TRAIL KING industries

NHTSA Recall Number: 24V670
Trail King Recall Number: TK202401

IMPORTANT SAFETY RECALL – 3rd NOTIFICATION

Inspection Criteria for the Gooseneck Lower Cylinder Mount:

Figure 1 – GN Inspection Location

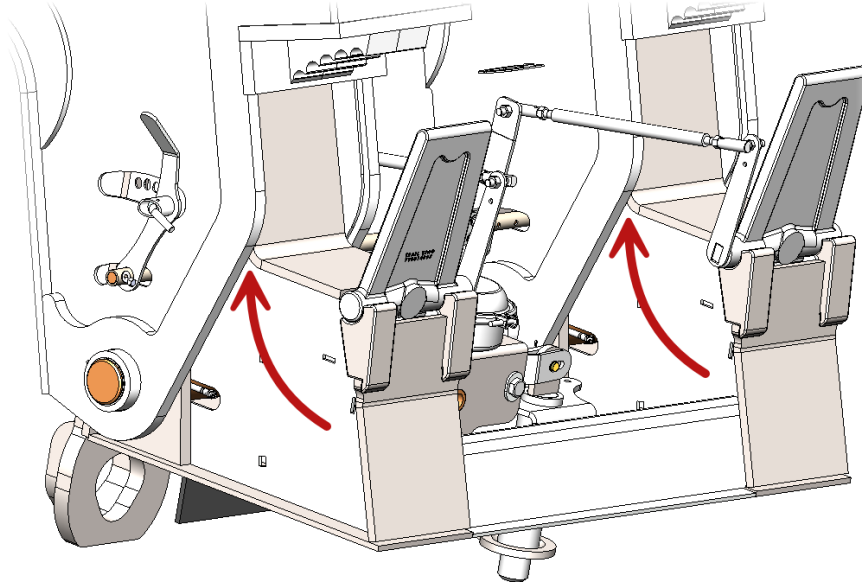
- All cracks will need to be evaluated by Trail King customer service to determine repairs.
- Inspect the webs near the bottom of the cylinder mounting plate to the riser panel web on the lower cylinder mount assembly. This will be visible on the outside and inside of the gooseneck during the gooseneck inspection.

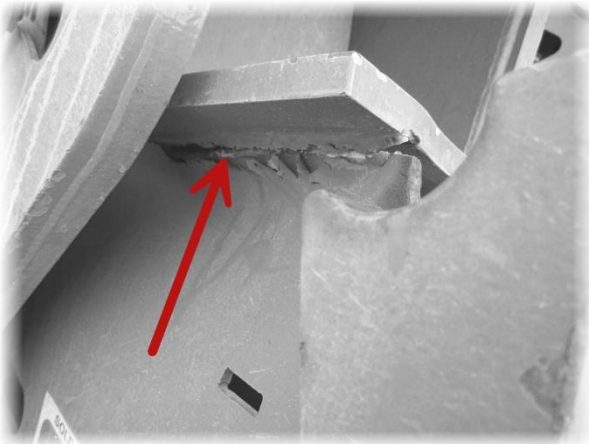
The picture above shows an example of a crack on the outside of the lower cylinder mount assembly.

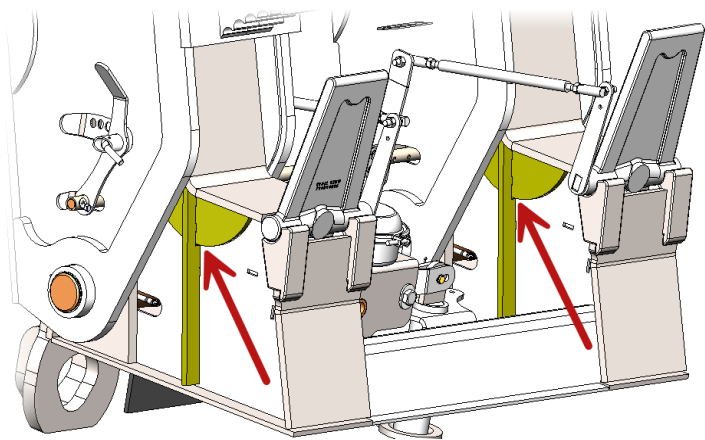
- Inspection should include looking for any cracks and/or for the added reinforcements. Note: These reinforcements should be on the outside and the inside of each lower cylinder mount assembly.

The picture above shows the newly added reinforcements. If the lower cylinder mount has these, no further measures need to be taken.
